ADDENDUM NO. 4

Date: **May 13, 2019**
Project: **Ltd. Renovations at Police Annex**
Contract No. P-18-001
3204 Amnicola Highway
Chattanooga, Tennessee 37406

Architect: **Billingsley/Architecture**
Suite 800 Republic Centre
633 Chestnut Street
Chattanooga, Tennessee 37450
(423) 752-0030

Project #:	1850
2/22/2019	
17-23	
JCP	
P1.1

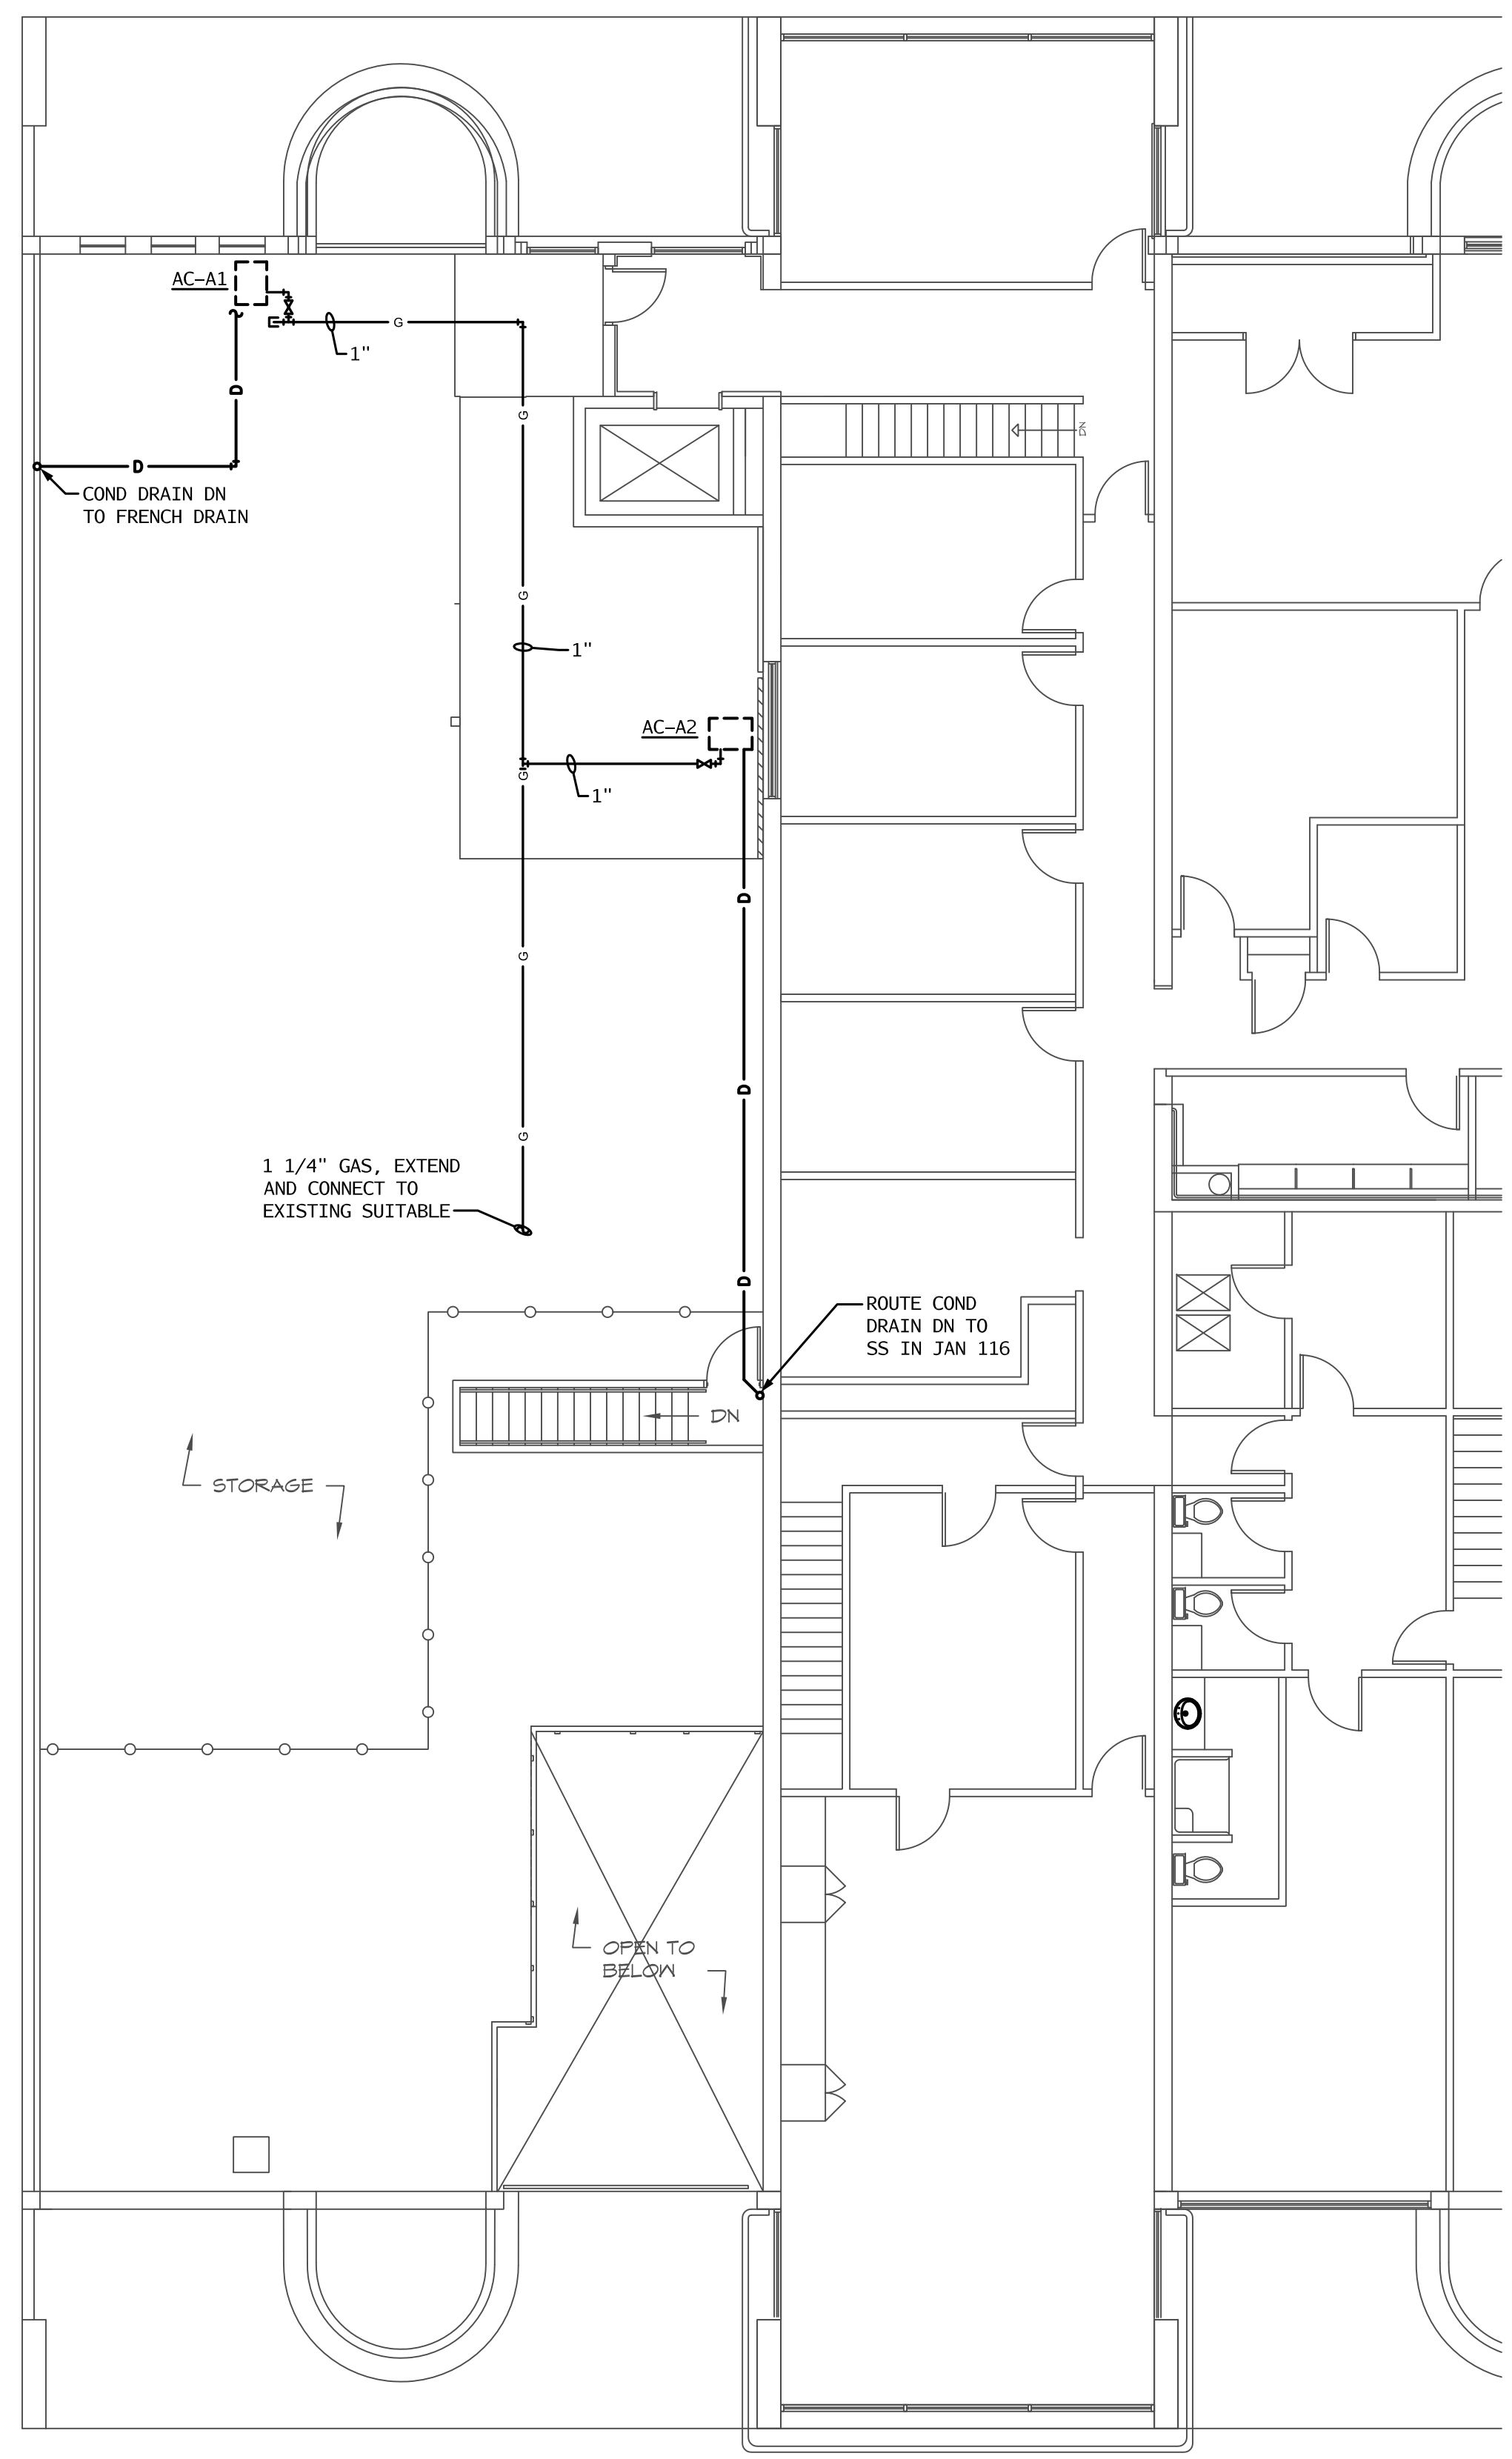
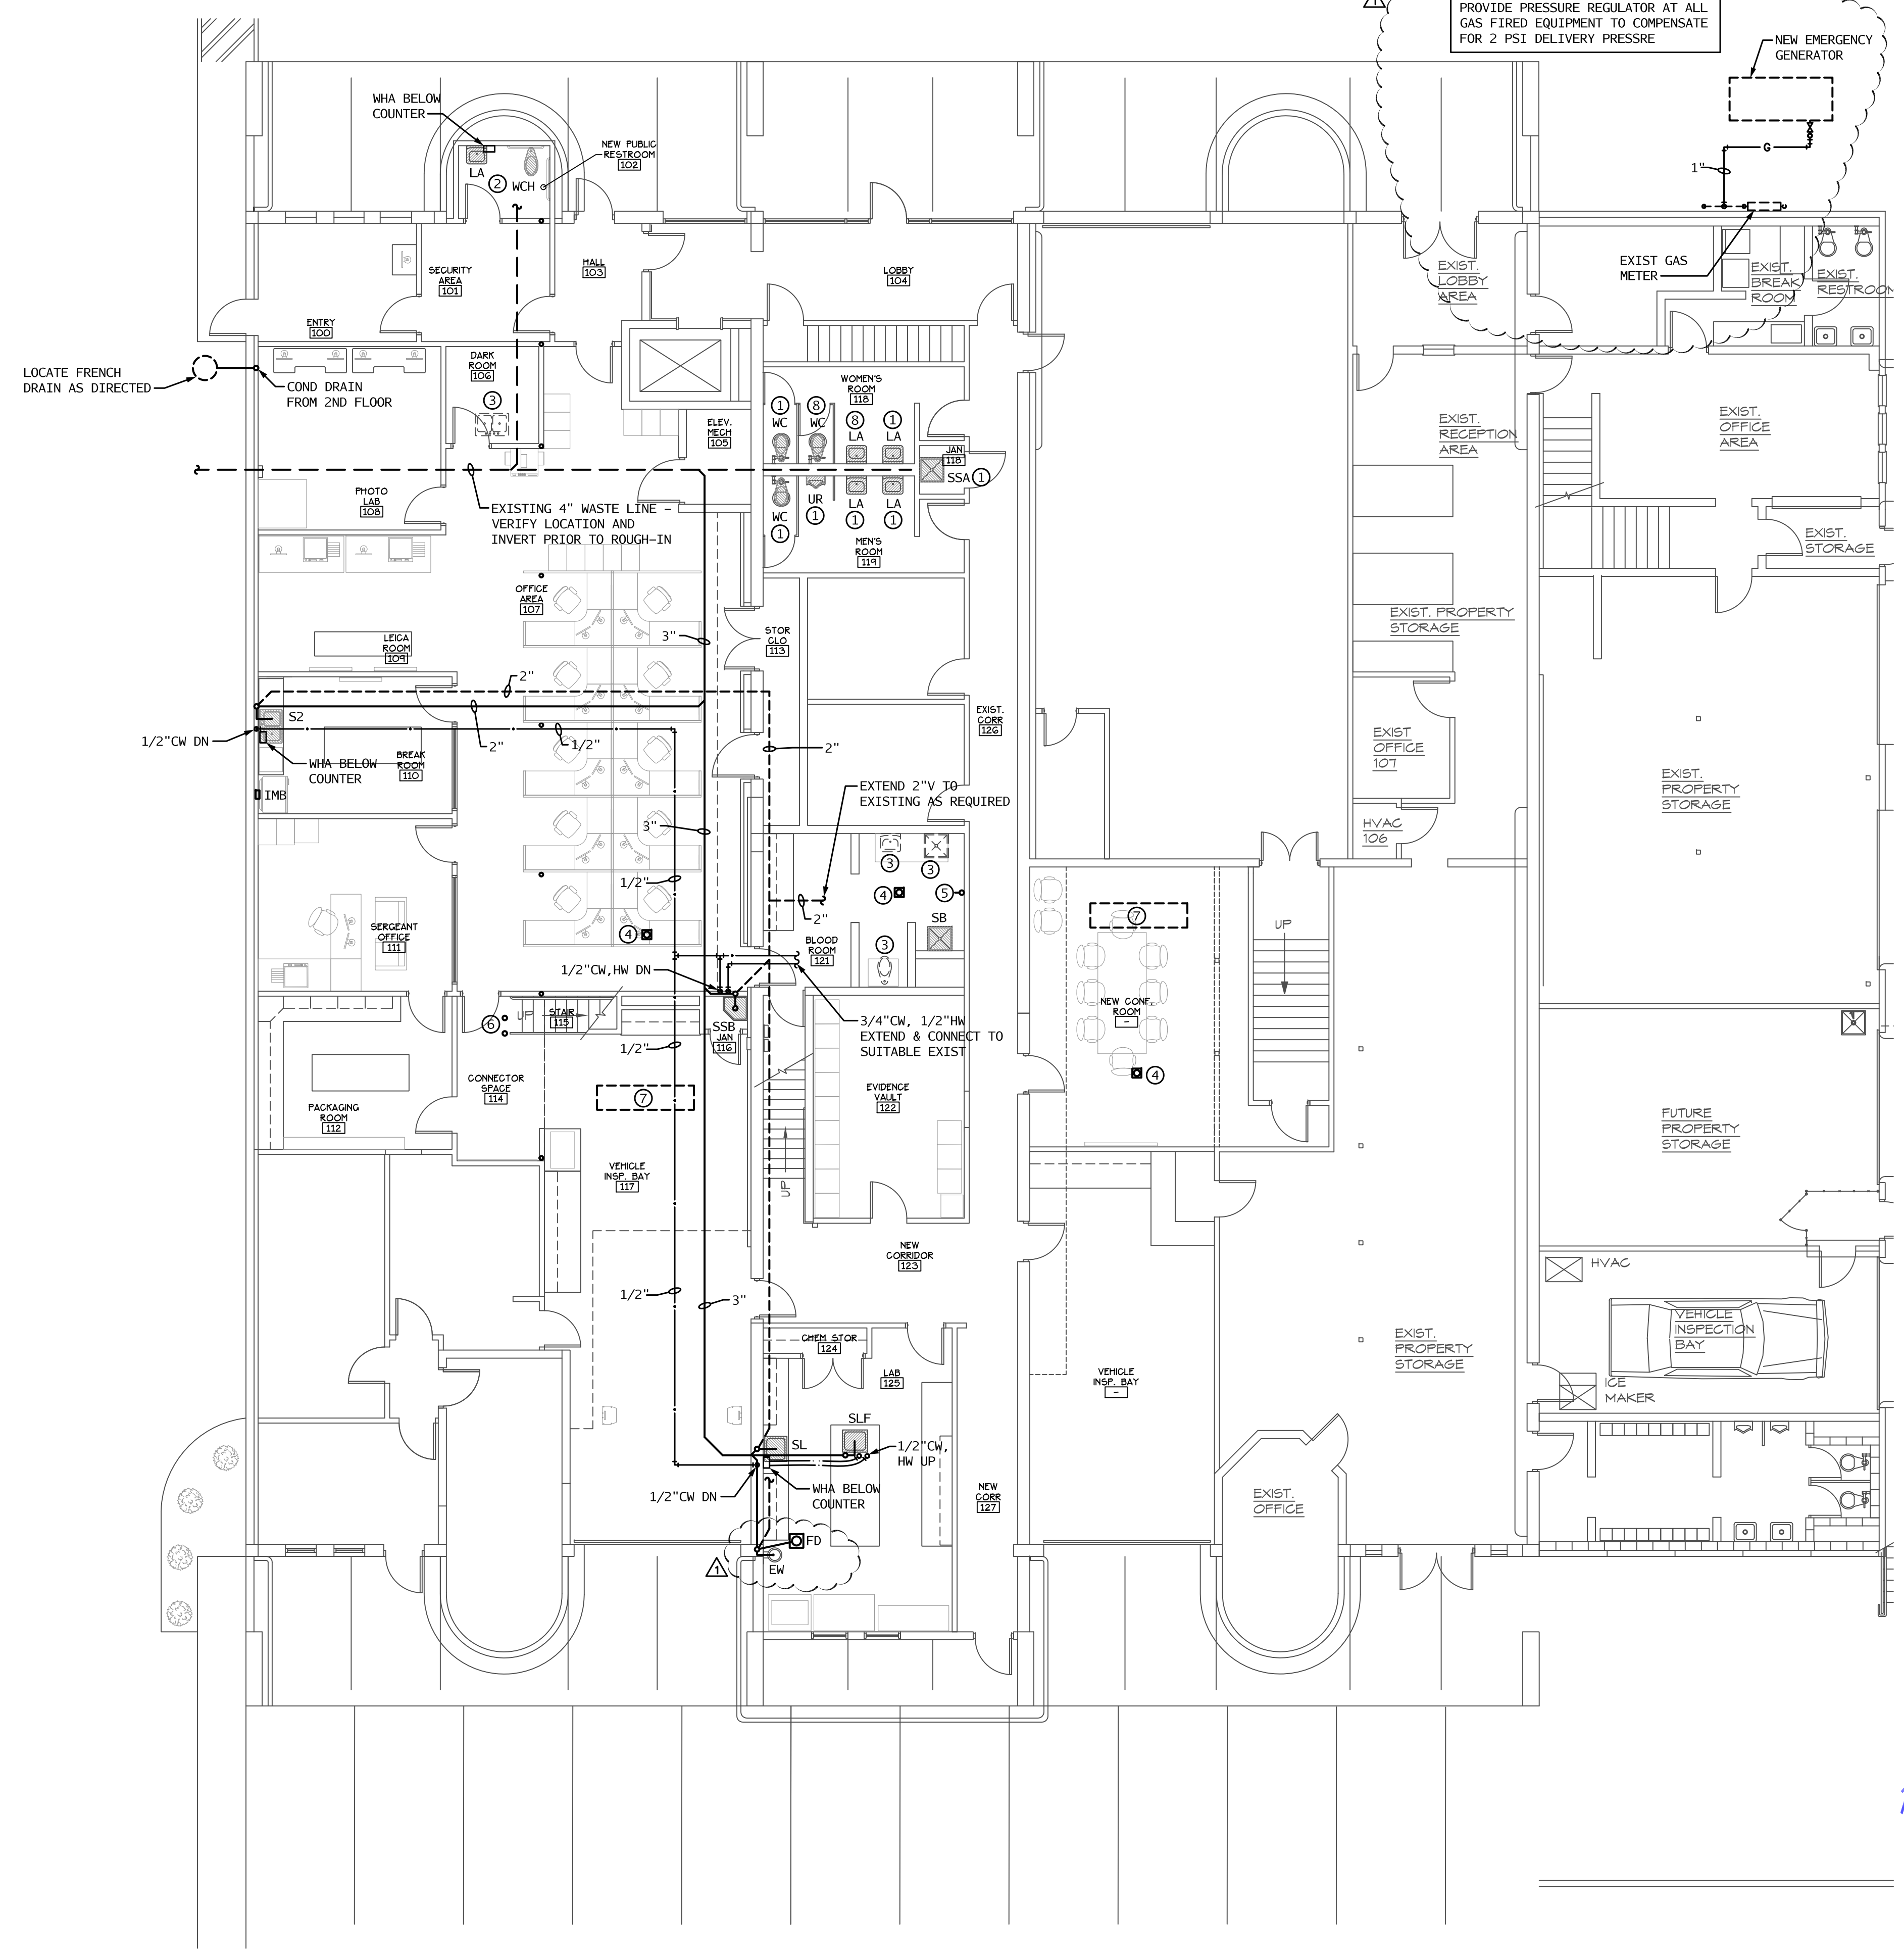
5. Sheet P1.1 Plumbing Plans
 - E. REVISED SHEET – Issued
 - g. Add new emergency generator and note.
 - h. Add floor drain.

1st FLOOR
HVAC PLAN

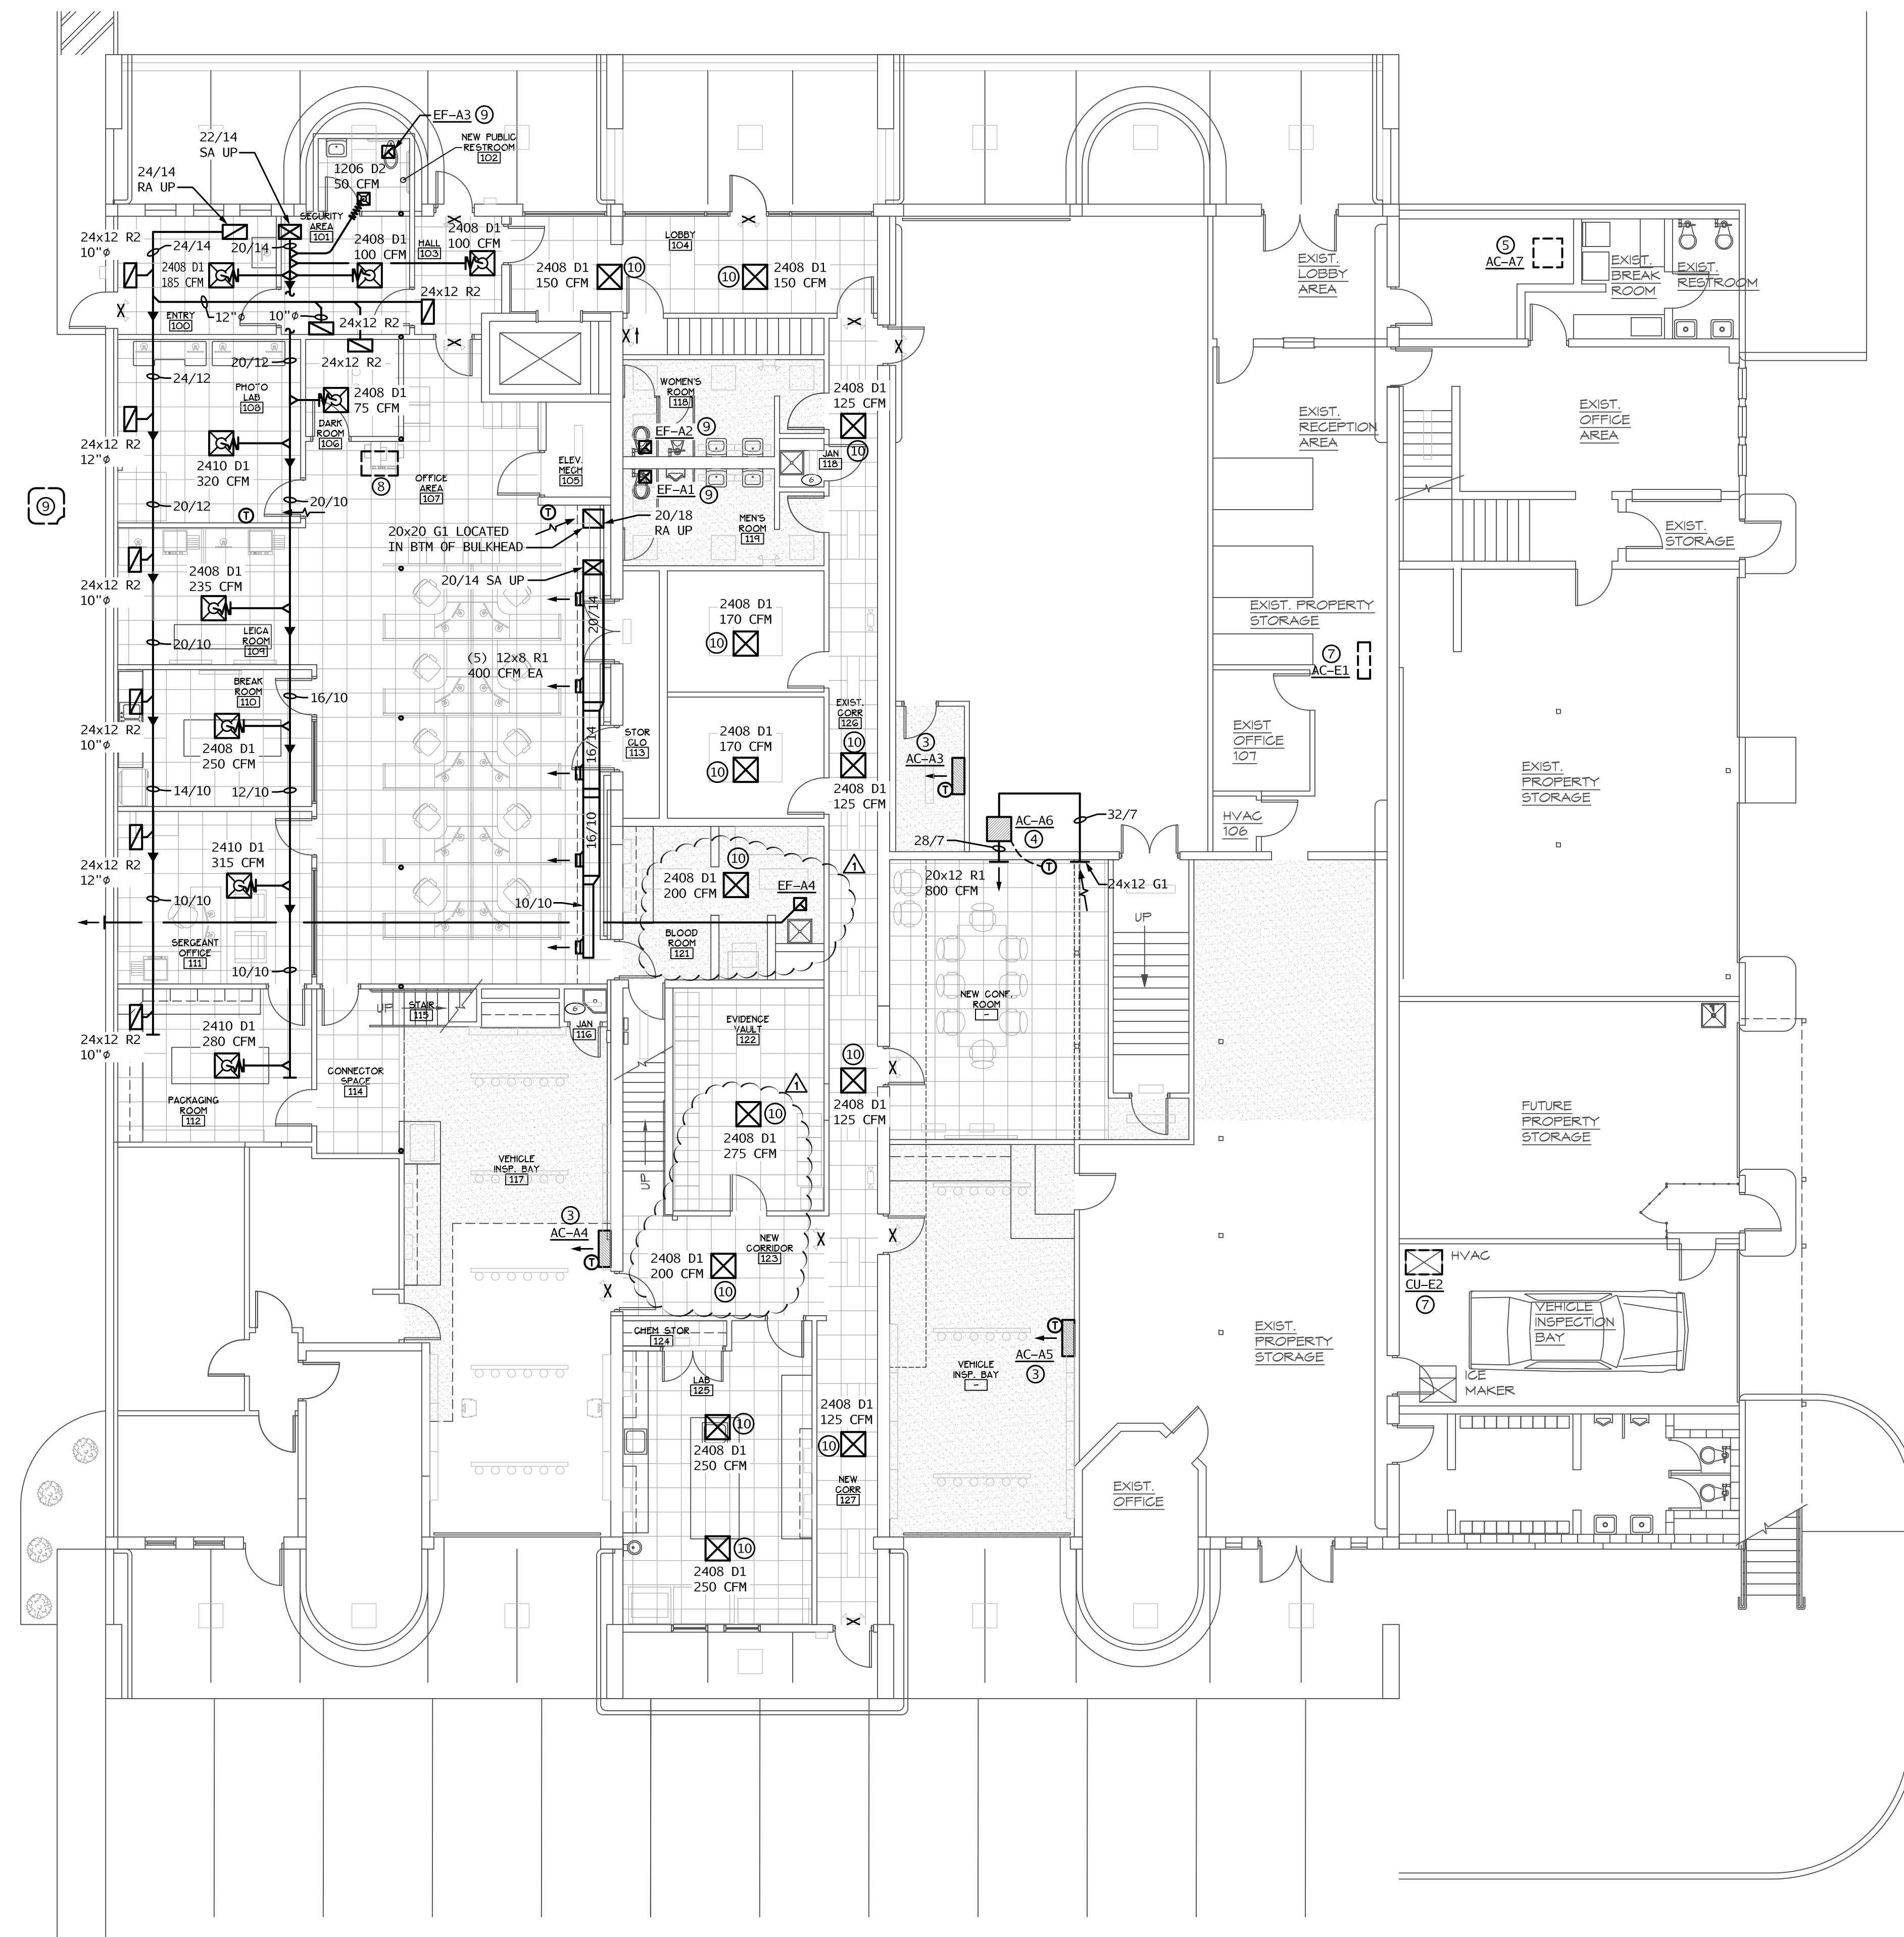
7. Sheet M1.1 First Floor HVAC Plan
 - G. REVISED SHEET – Issued
 - k. Changed CFM's at supply registers at Evidence Vault 122 and New Corridor 123.
 - l. Add exhaust fan at Blood Room 121.
